COUNCIL SUPPLEMENTARY ASSESSMENT REPORT

SYDNEY WESTERN CITY PLANNING PANEL

PANEL REFERENCE & DA NUMBER	DA 167.1/2023 PAN-333433 PPSSWC-337
PROPOSAL	Demolition of existing buildings and staged (Stages 1 and 2) construction of a mixed-use development up to 19 storeys comprising basement carparking over which will be a new market square, three (3) buildings containing ground level retail and a tavern, first floor commercial and a restaurant as well as 358 apartments above. The DA also includes public domain improvement and associated stormwater works.
ADDRESS	<ul style="list-style-type: none"> - Lot: 7 Sec: E DP: 4420 No. 76 Broomfield Street, Cabramatta - Lot: 1 DP: 205759 and Lot: 10 DP: 255023 No. 84 Broomfield Street, Cabramatta - Lot: 2 DP: 205759 No. 86 Broomfield Street, Cabramatta - Lot: 2 DP: 580587 No. 139 Cabramatta Road East, Cabramatta - Lot: 8 DP: 25618 Nos. 147 – 149 Cabramatta Road East, Cabramatta - Lot: 5 DP: 25618, Lot: 6 DP: 25618 and Lot: 7 DP: 25618 No. 151 Cabramatta Road East, Cabramatta

Table S5C11b: Type A construction: FRL of non-loadbearing parts of external walls

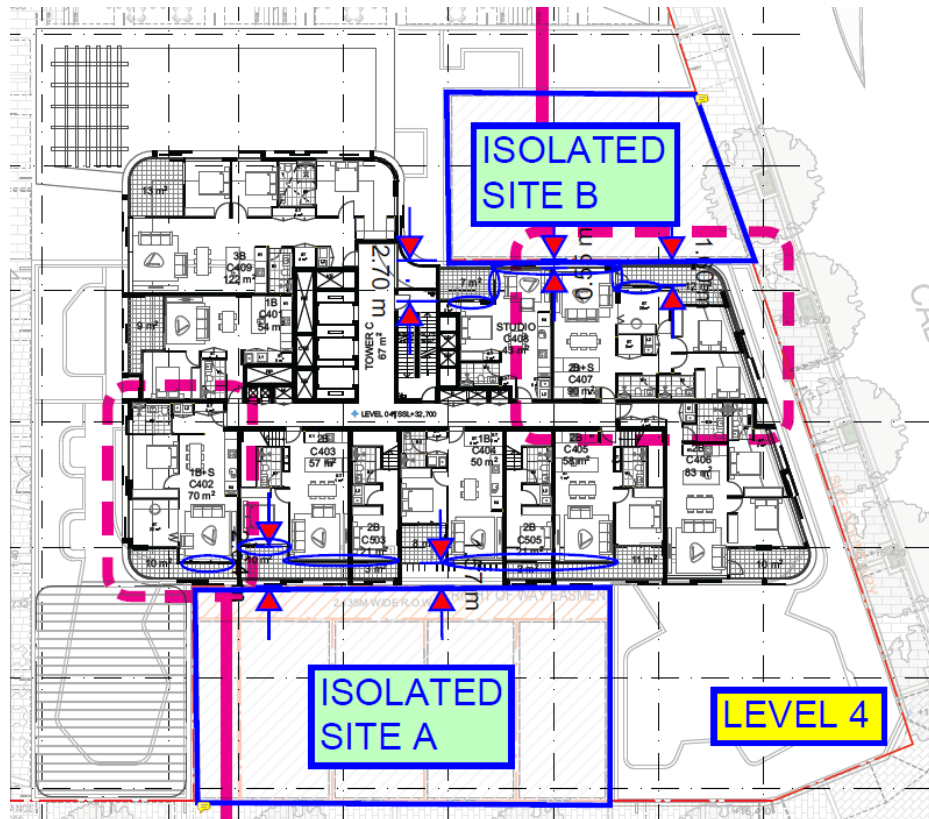
The west elevation wall appears to be non-loadbearing walls. In accordance with BCA Table S5C11b, the west elevation wall is to be fire rated and/or openings protected within sprinklers.

If sprinklers with fixed glazing are provided to Levels 3 and above, compliance with BCA DTS provisions can be achieved.

TOWER C (LEVEL 4)

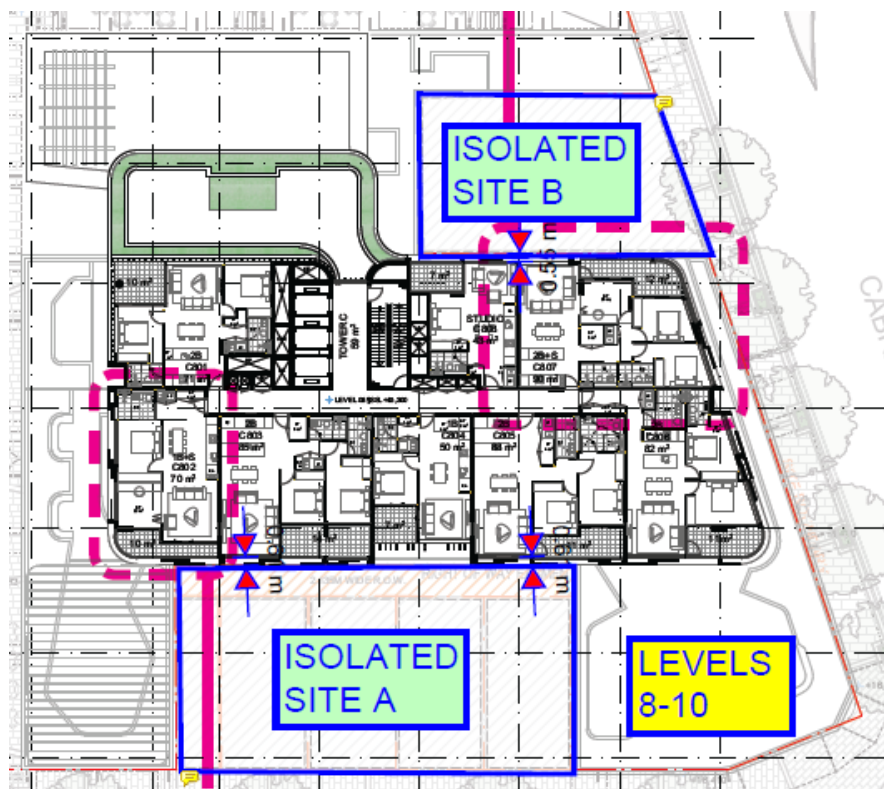
3. By reference to an extract from the Tower C Level 4 floor plan below, there are:
 - a. Window and door openings less than 3m from the boundary with isolated site B, with some openings scaled at approximately 0.55m from the east boundary.

- b. Window/door openings less than 3m from the boundary with isolated site A, with some openings scaled at approximately 1.6m from the west boundary.

4. External wall openings at Levels 05-07 have similar boundary setbacks to Level 4.
5. By reference to an extract from the Tower C Level 08-10 floor plan below, there are:

- a. Window and door openings less than 3m from the boundary with isolated site B, with some openings scaled at approximately 0.55m from the east boundary.

- b. Window/door openings less than 3m from the boundary with isolated site A, with some openings scaled at approximately 0.55m from the west boundary.

6. External wall openings at Levels 11-16 have similar boundary setbacks to Levels 08-10.
7. The potential for loss of natural ventilation and loss of natural light to Tower C units from a future development of isolated sites A or B has not been adequately considered.

Based on this, it is considered that the BCA matters have not been resolved and solutions to address the matters would impact Tower C and its compliance with the ADGs. Given the above, it is considered that the amended application has not resolved this matter.

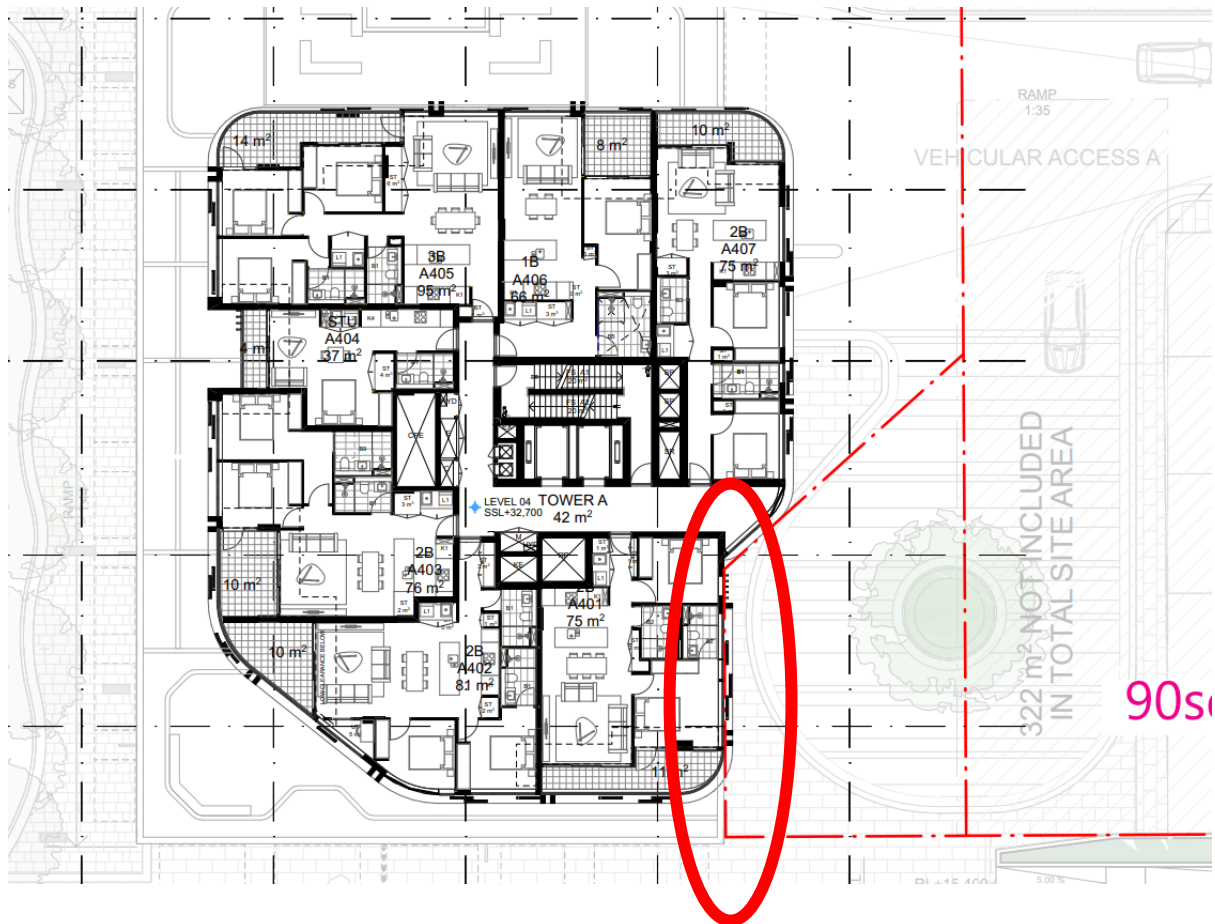
The amended application has been specifically amended in order to remove the proposed development outside of the Council owned land (being part of the head of the cul de sac). The amended plans have relocated the basement level wholly within the confines of the subject site, however, there are some minor encroachments of Tower A. This is depicted in the following figures:

The proposed development would need to be setback wholly within the subject site and not encroach into Council land. In order to satisfactorily address this matter, the dwellings that are affected by this change may not meet the minimum floor areas required under the Apartment Design Guidelines.

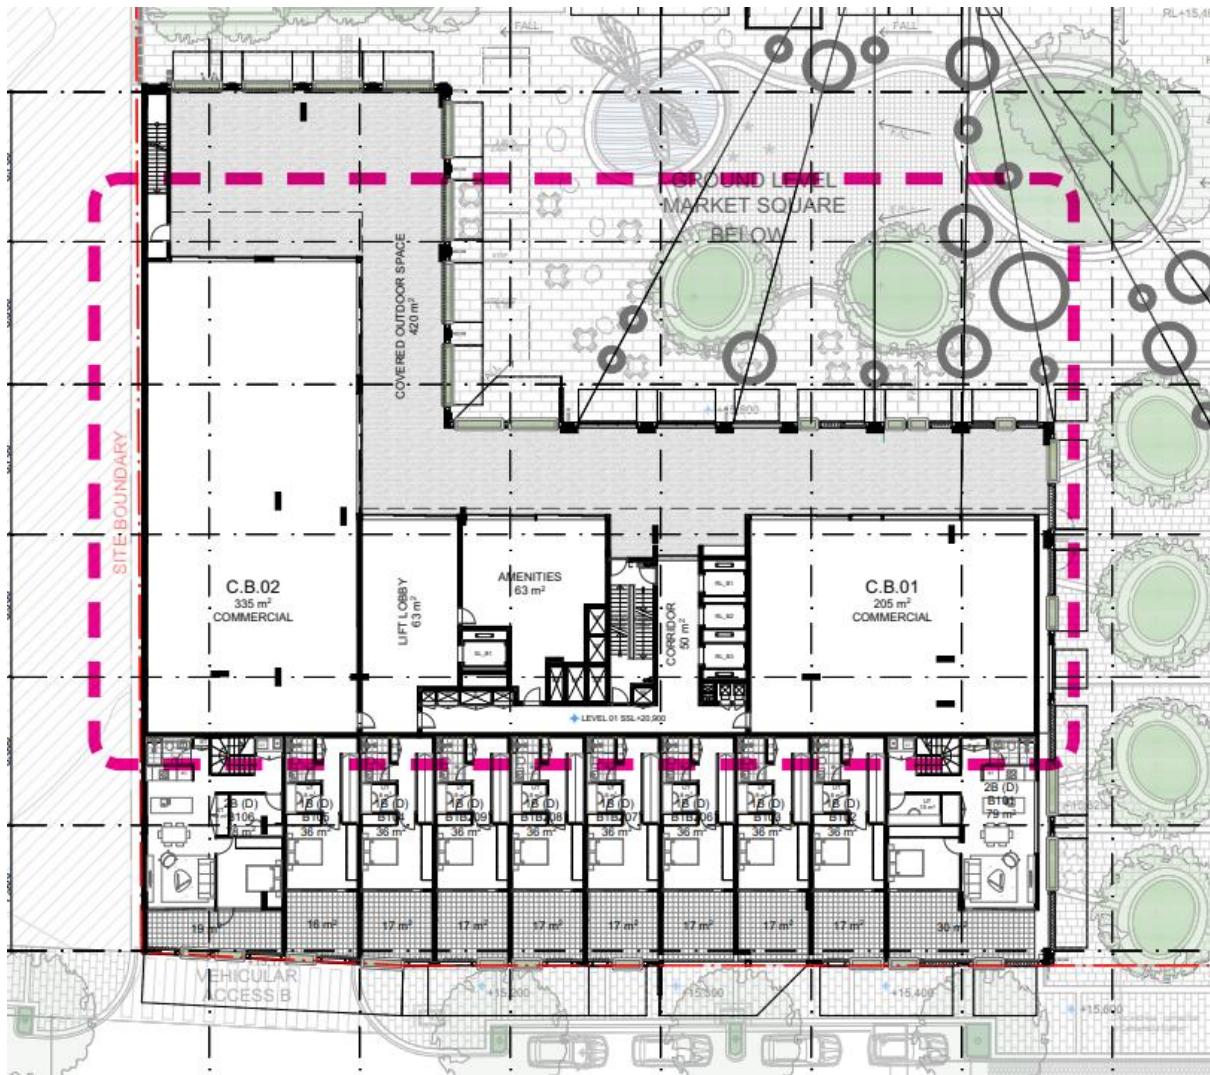
The amended application has removed the childcare centre from the proposed development and replaced this area with commercial space. Despite this, there has been no change to the layout or building for the proposed commercial premises. This is depicted below:

The proposed commercial area will have a large 420m² covered outdoor space. An outdoor area of this size is considered to be unusual for a commercial premises and no information has been submitted to provide details of how this area will operate and would not impact the residential dwellings located within the development.

An example of the layout of a 3-bedroom unit within the initial Application.

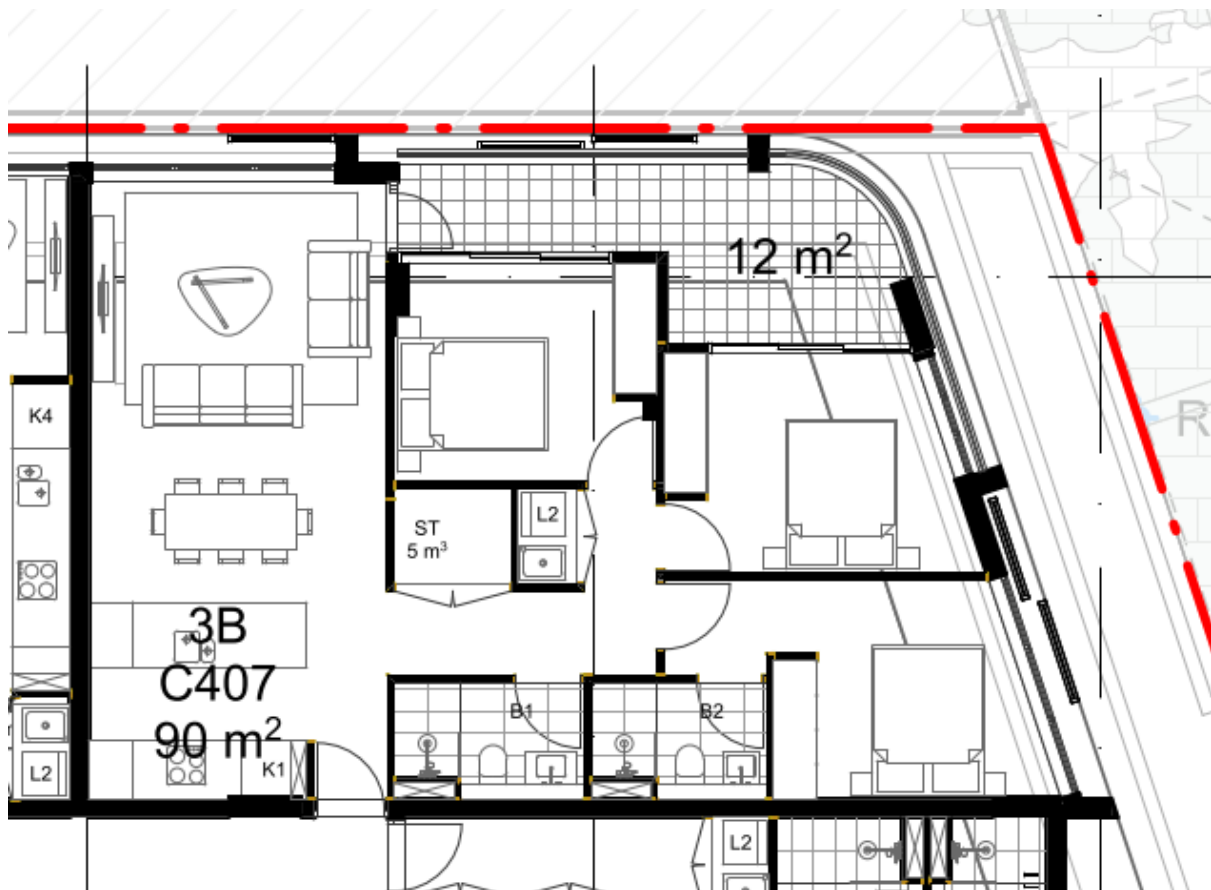
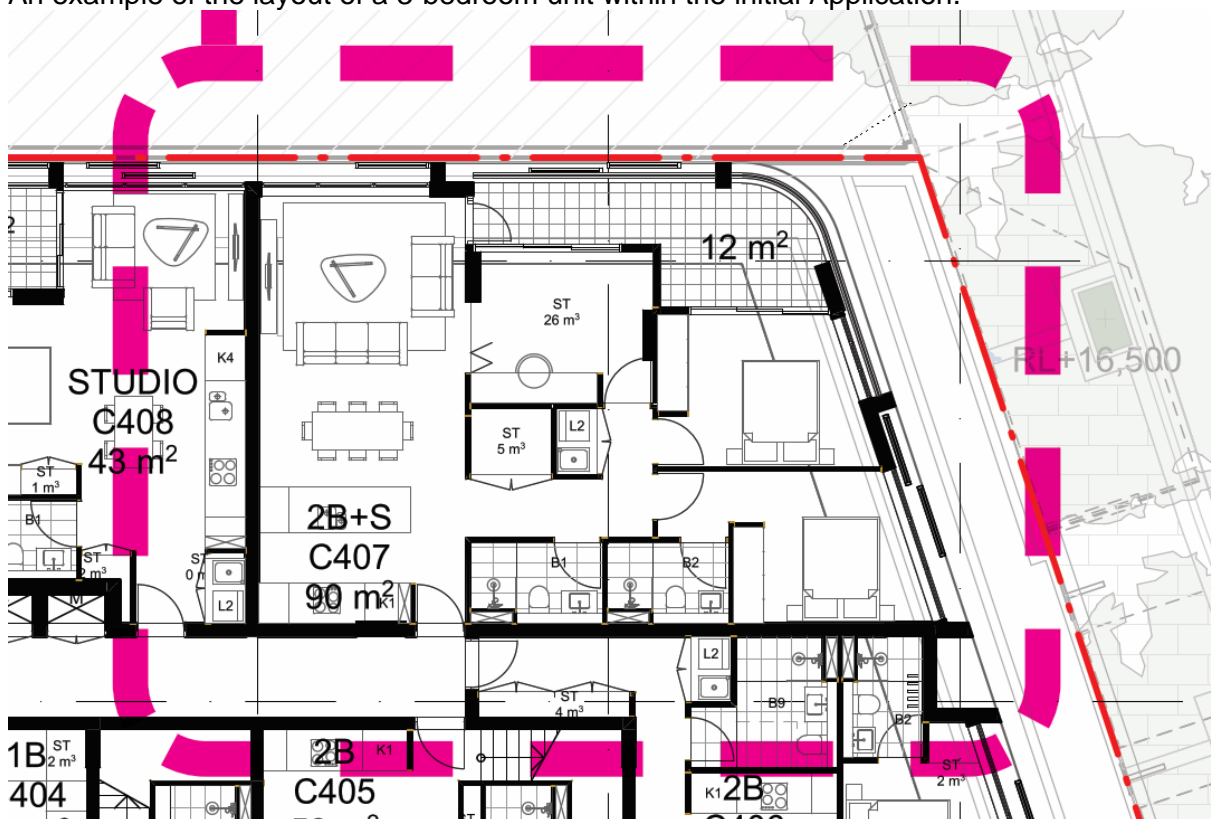
The amended application has not reduced the number of dwellings onsite, however, has amended 22 of the proposed dwellings in order to reduce the number of bedrooms. Notwithstanding this, it is considered that the amended layout which substitutes 'studies' for bedrooms in name only are still capable of being used as bedrooms and an example of this is provided below:

In the case above, the amended application has not reduced the size of the unit/room and has removed part of an internal wall and replaced it with what appears to be a bifold/concertina door. The room has been labelled as study and still includes a wardrobe. Given that the 10m² room can be closed off it is still considered to be capable of being a bedroom. Merely changing the name of the room from bedroom to study in order to reduce the car parking requirement is not appropriate and is not considered acceptable.

It is considered that the proposed studies within the amended application are capable of functioning as a bedroom and therefore should be considered as a bedroom.
